United States Department of the Interior

February 23, 2024

Subject: U.S. Department of the Interior Comments – *Draft American River Common Features, 2016 Flood Risk Management Project, Sacramento, California, Supplemental Environmental Impact Statement/ Subsequent Environmental Impact Report XIV.*

Figure 3

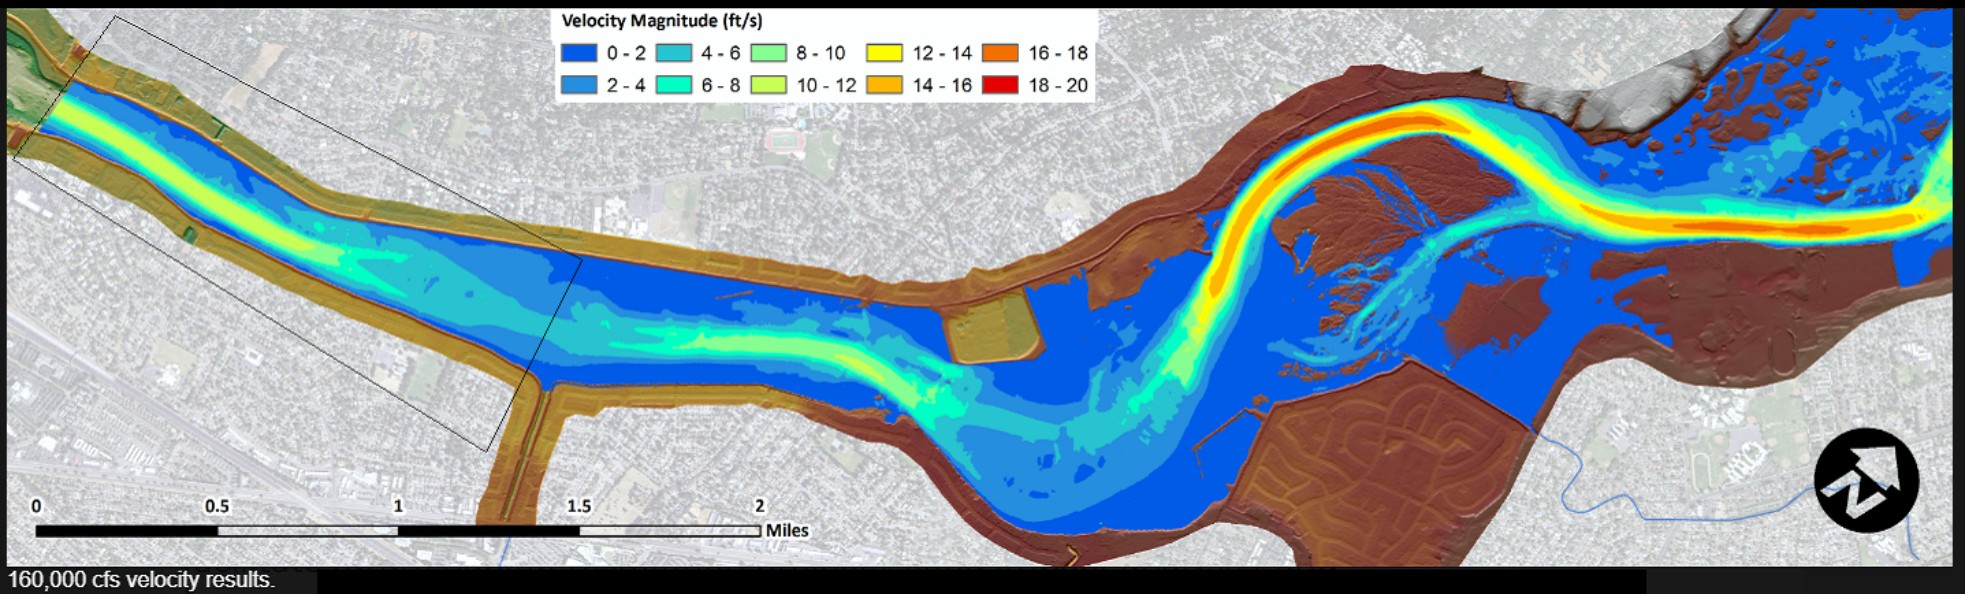
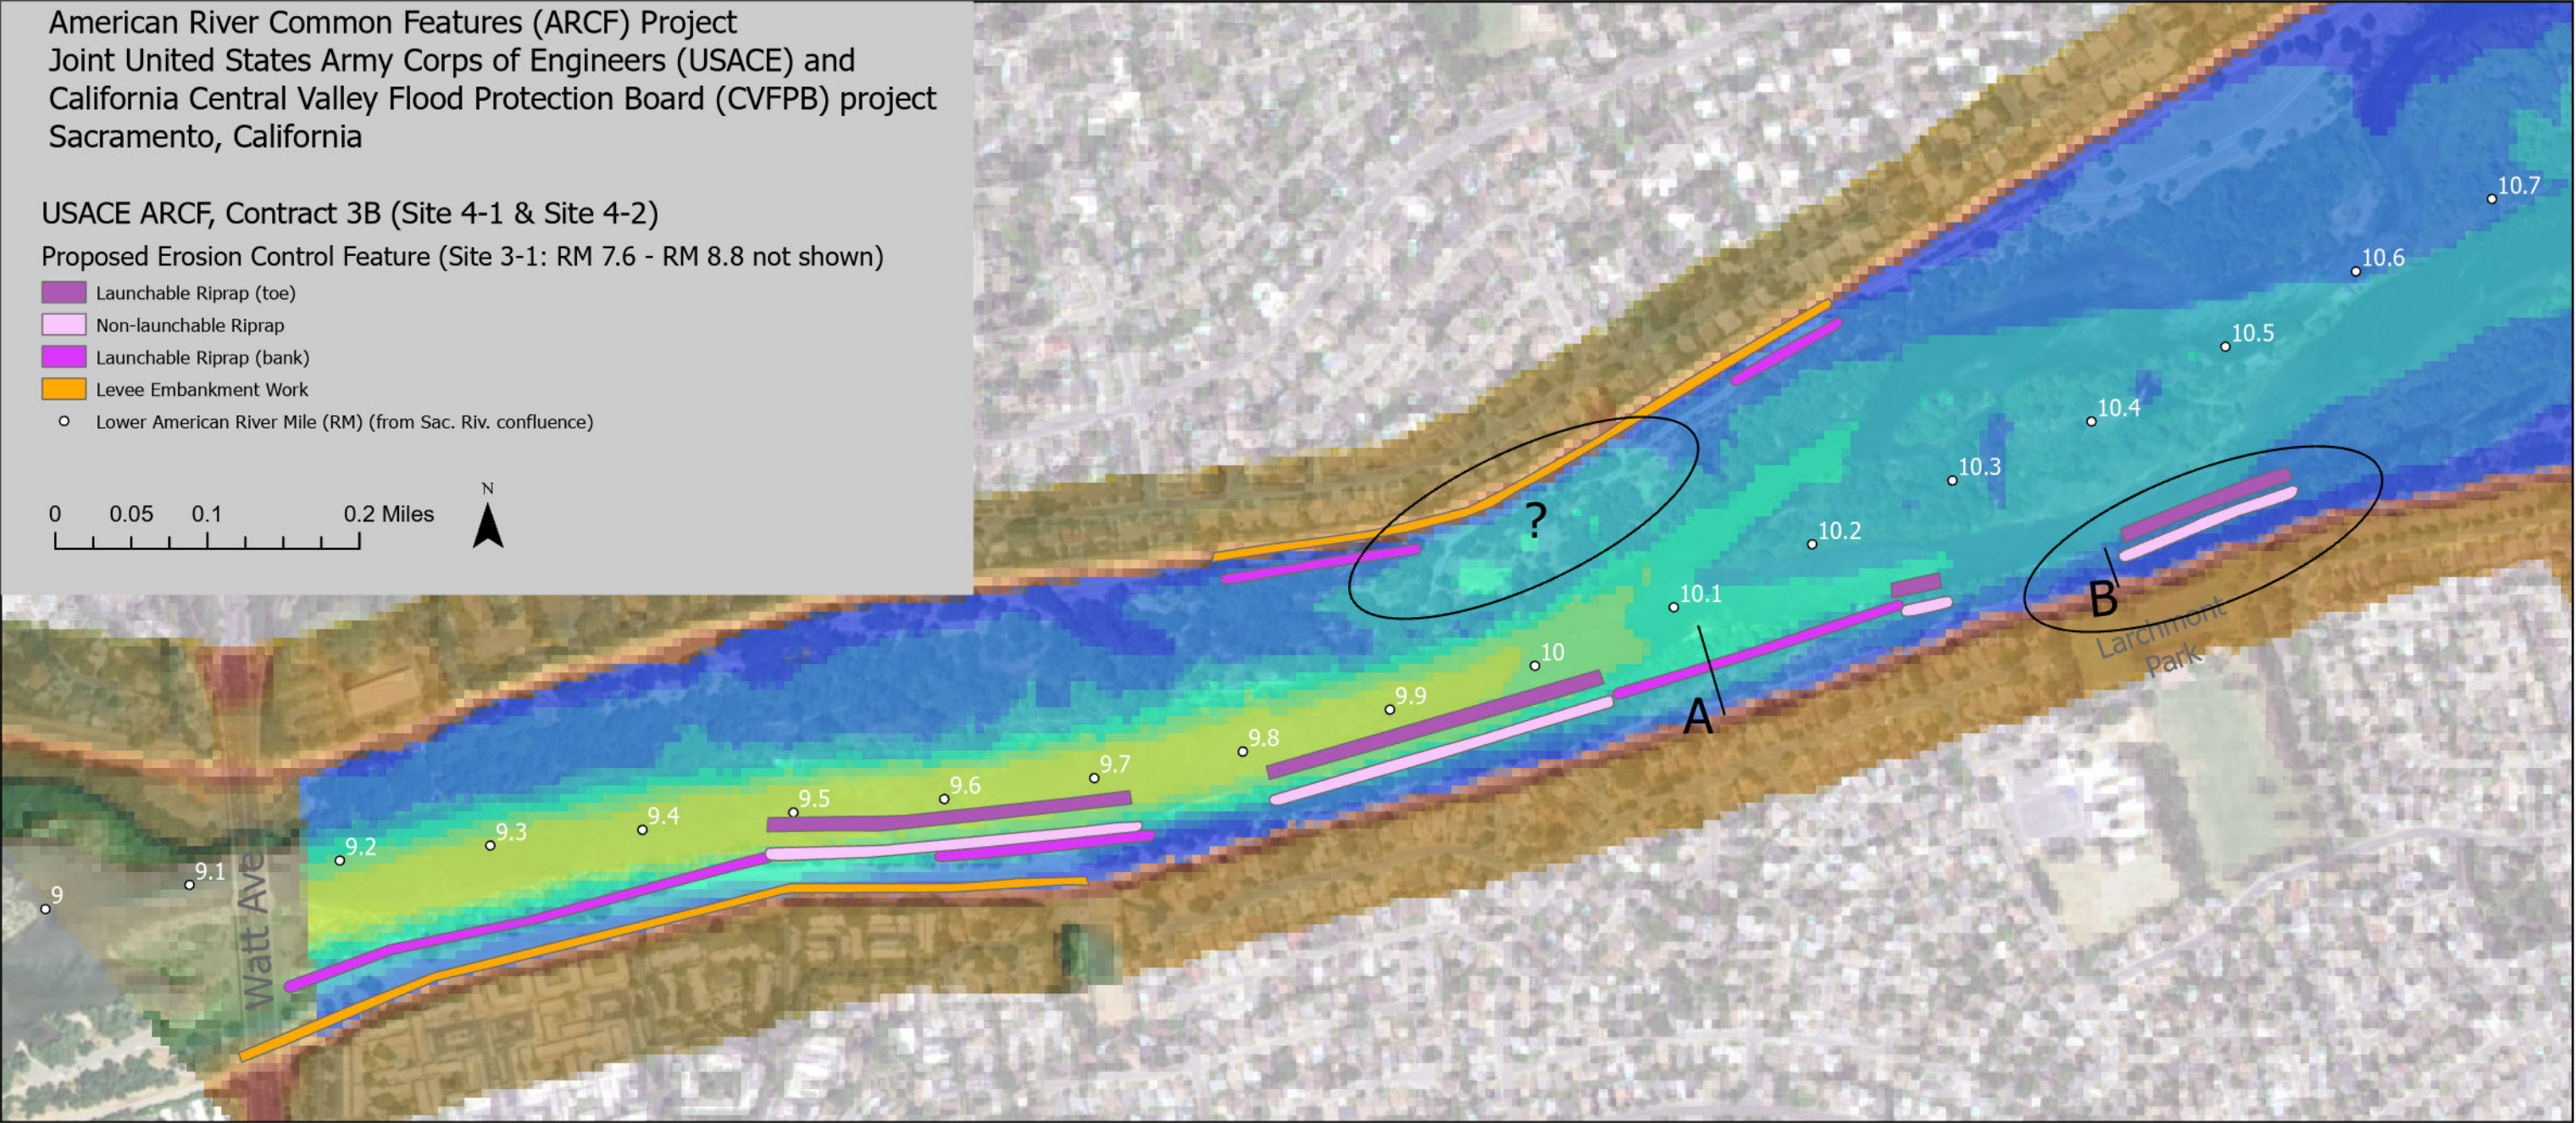
This figure shows the original resolution of the depth-averaged 160 kcfs model velocity output found online (at right) and how it's better resolved than the 2004 output when zoomed into some of the Project footprint (below). Note erosion control features are planned in low-velocity "B" area and none are planned in the higher velocity "?" area where the channel thins.

Figure 4

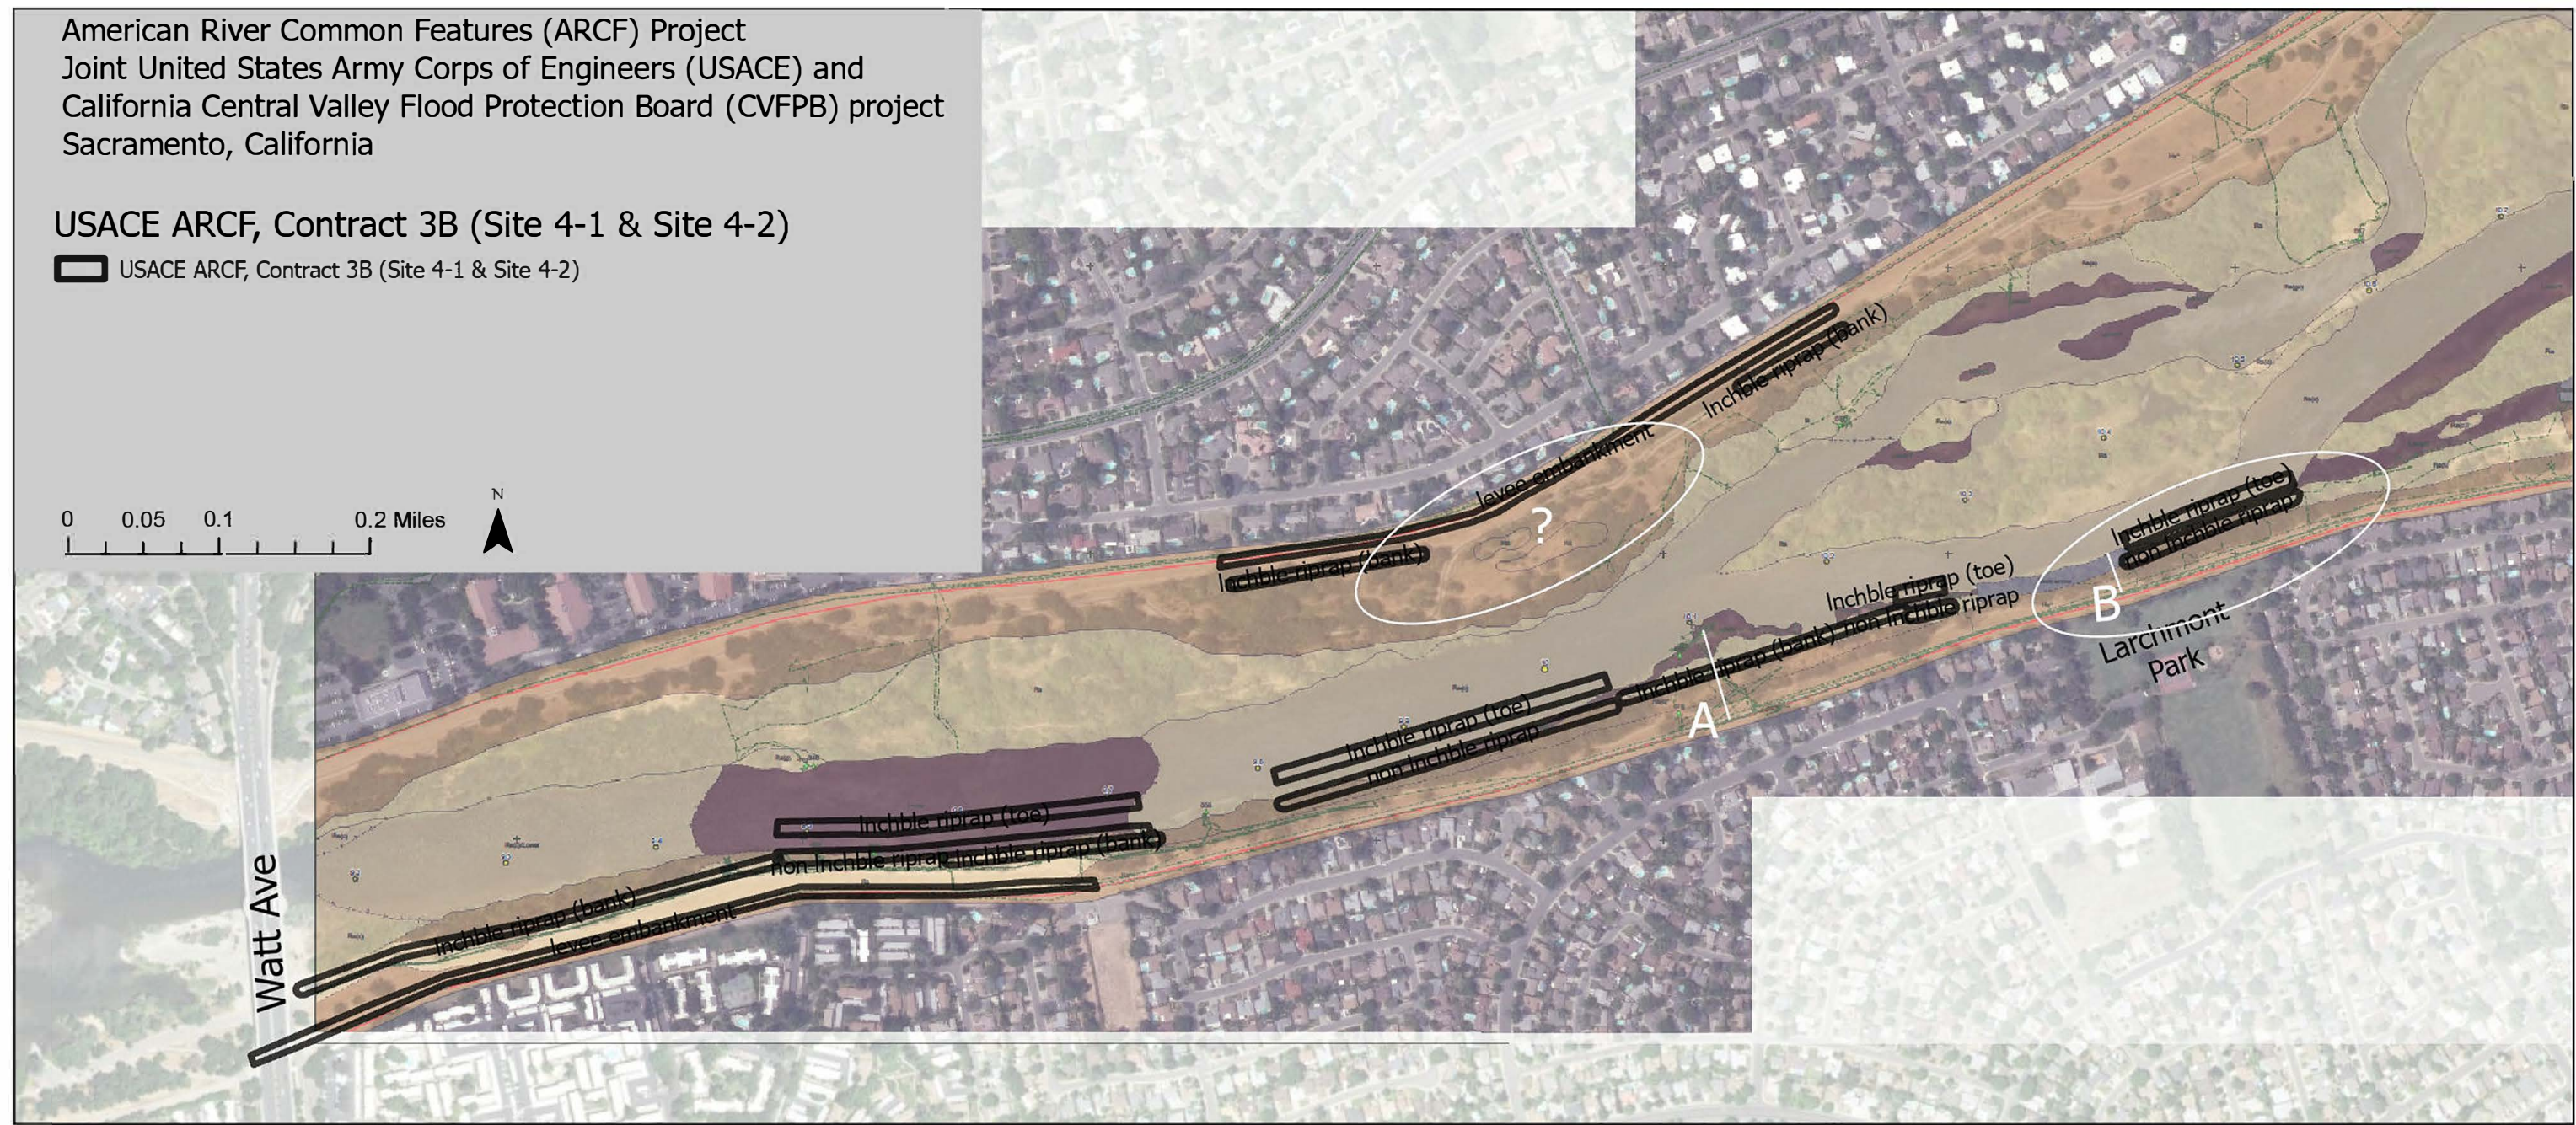
Similar to comment 12, Appendix A – Additional Report Figures, Figure 4 and Figure 8 show how georeferenced Erosion Control Protection Features intersect with mapped geology, as the two were not shown in context with each other in the FEIR/FEIS or SEIR/SEIS or discussed significantly. Some erosion control features are identified to be located entirely within the Lower Erosion Resistant Unit of the Plio-Pleistocene Fair Oaks formation (ie, Launchable Toe protection planned for River Mile 9.4 – 9.7), and in general little to no pattern is discernible connecting planned features to mapped geologic units. What is the rationale behind this decision?

This figure shows the intersection of Erosion Control Features with detailed geologic mapping conducted in 2012 (Fugro 2012). Note some features are planned to be wholly within the Lower erosion resistant unit of the Fair Oaks formation.

Figure 5 related to comment 55 and 57

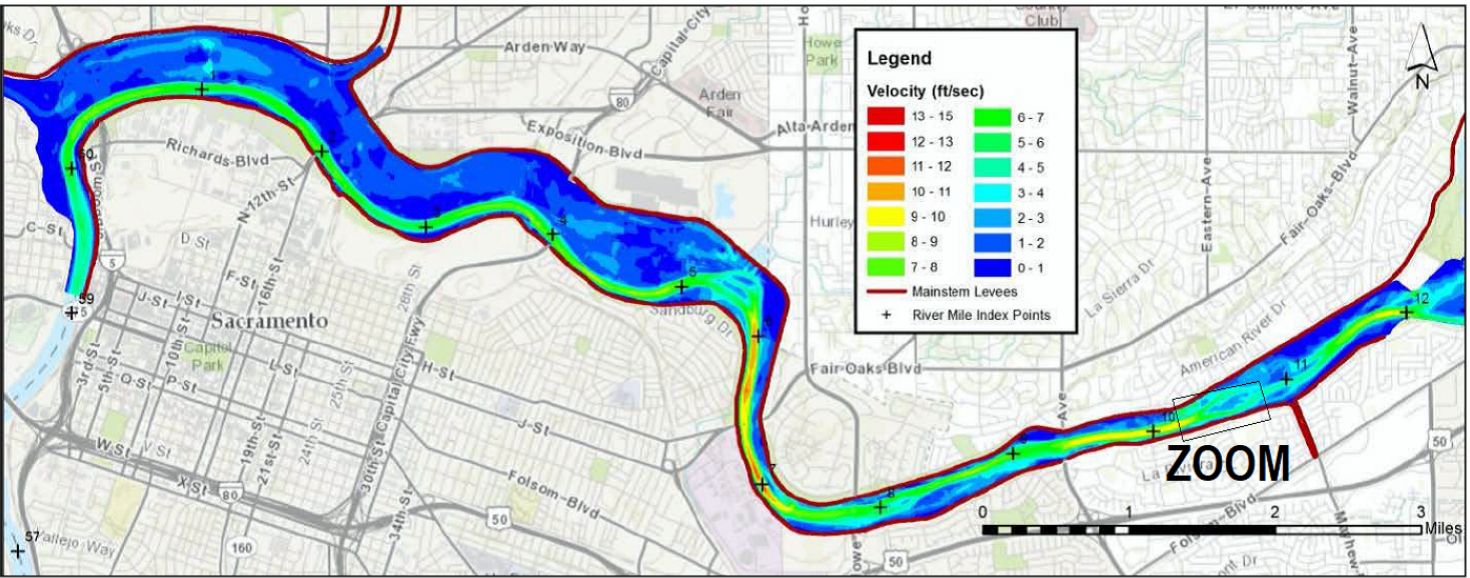
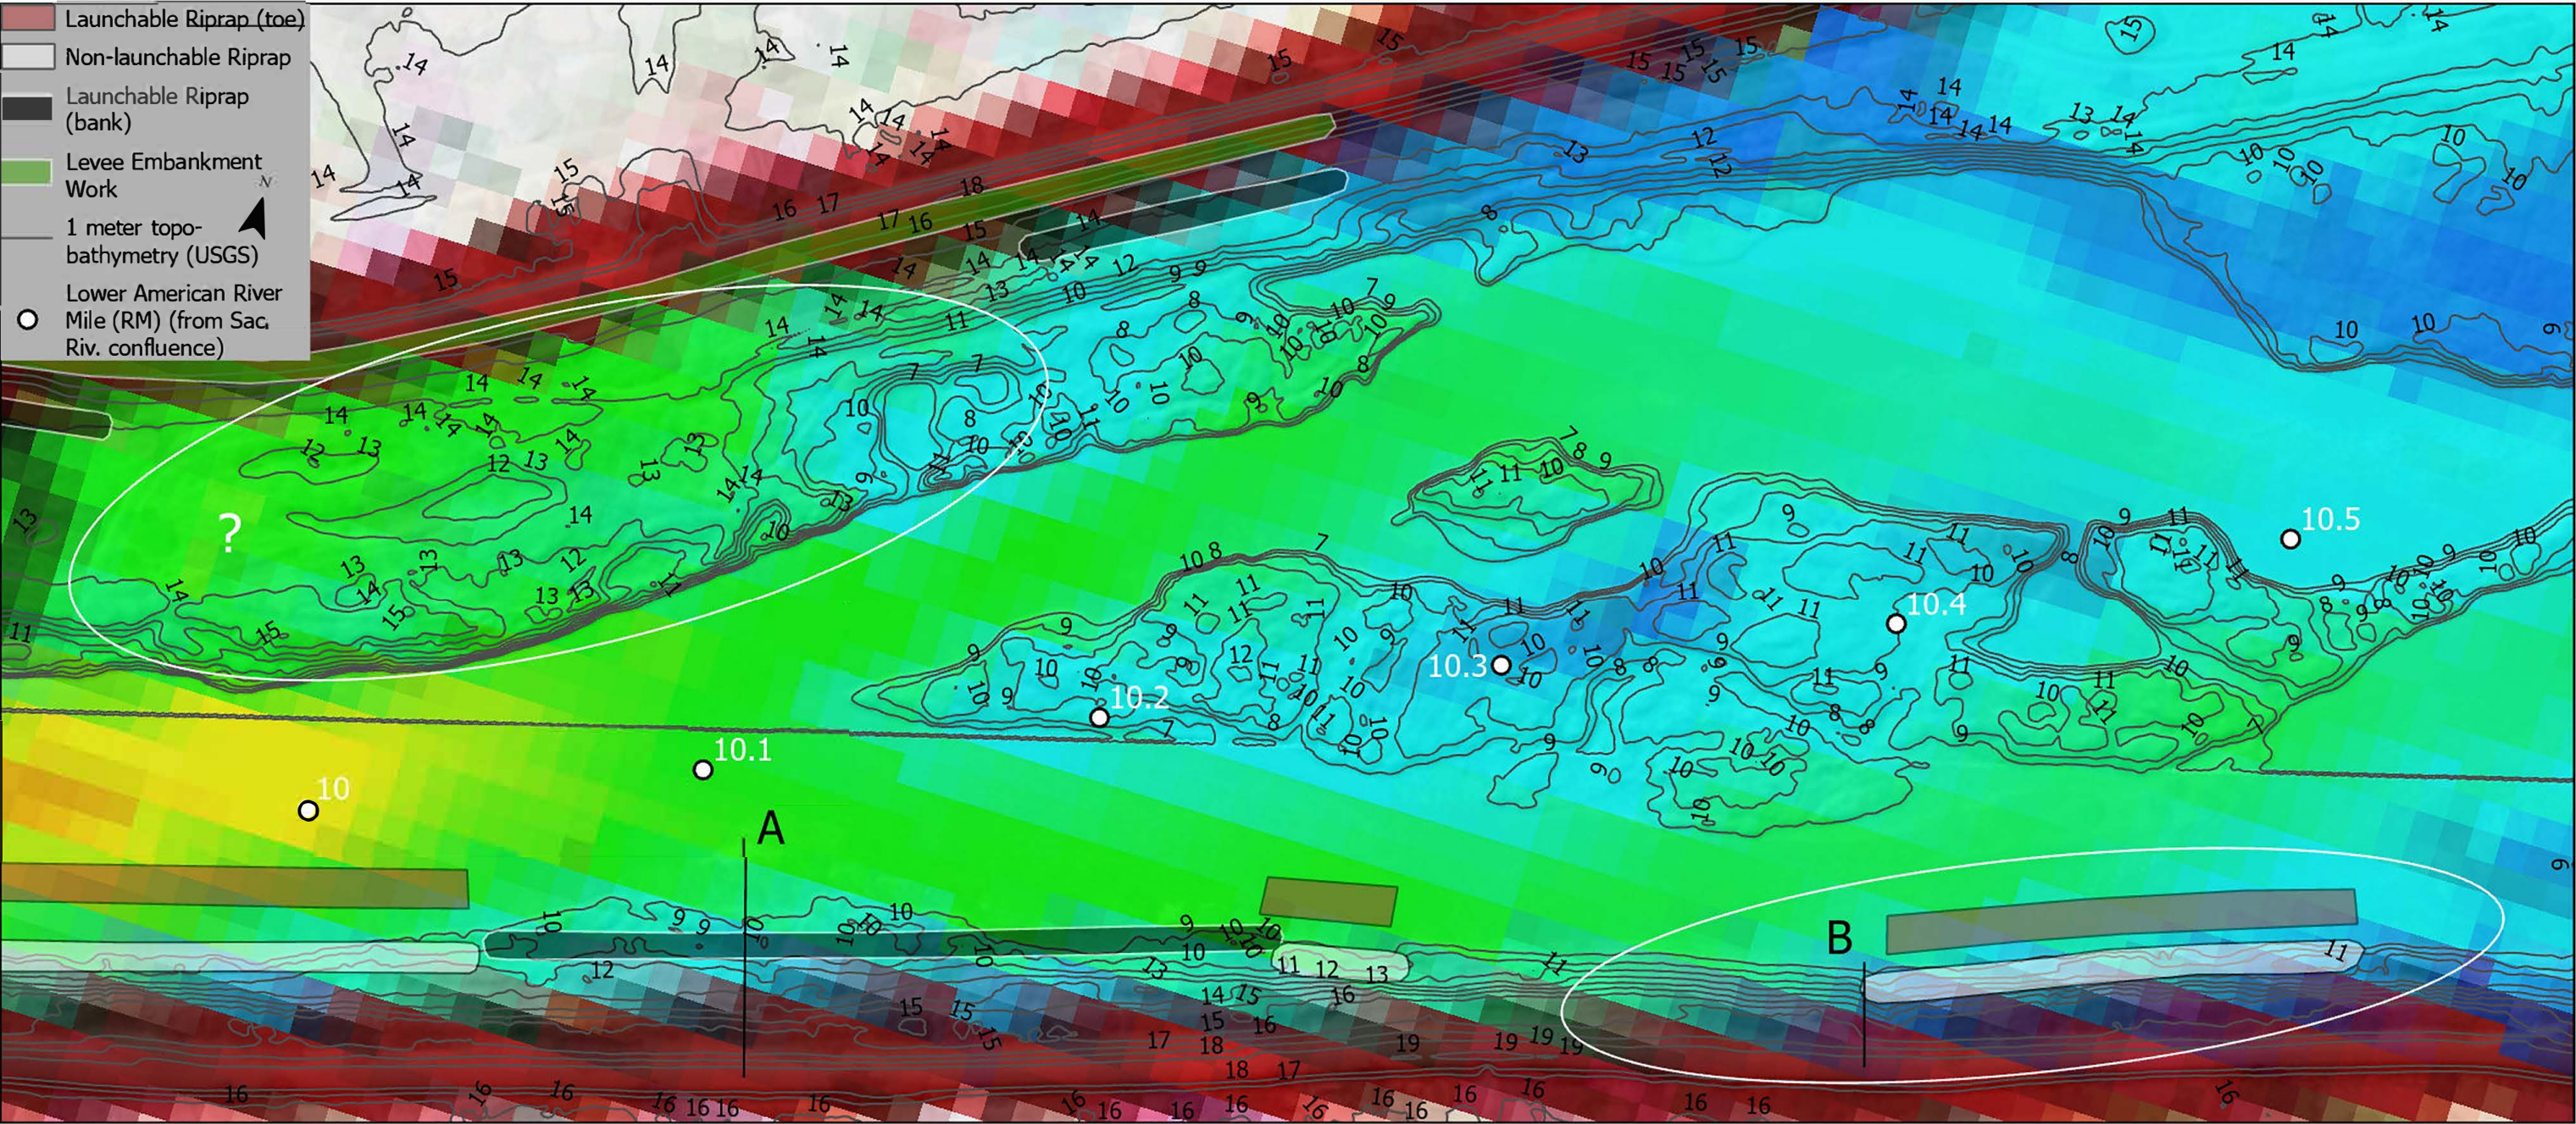
Similar to comment 12 and 13, Appendix A – Additional Report Figures, Figure 5 shows georeferenced features in context with detailed topo-bathymetric data provided by USGS. At River Mile 10.1 line “A” shows an erosion control feature planned for a very gently sloping river bank and line “B” at River Mile 10.4 shows a considerably steeper and thinner river bank, though with no erosion control features planned from “B” to River Mile ~10.25. What is the rationale behind these decisions?

This figure shows significant topographic detail that's readily available but not presented in the FEIR/FEIS or SEIR/SEIS and raises questions about the work. Note transect A ("clay banks area") represents a thick, gradually sloped section of riparian forest and at baseflow conditions such as shown below, approximately 350 ft from levee top to river water edge. In contrast, transect B (<150 ft) shows thinner and steeper riparian forest, with no features planned over a considerable downstream area.
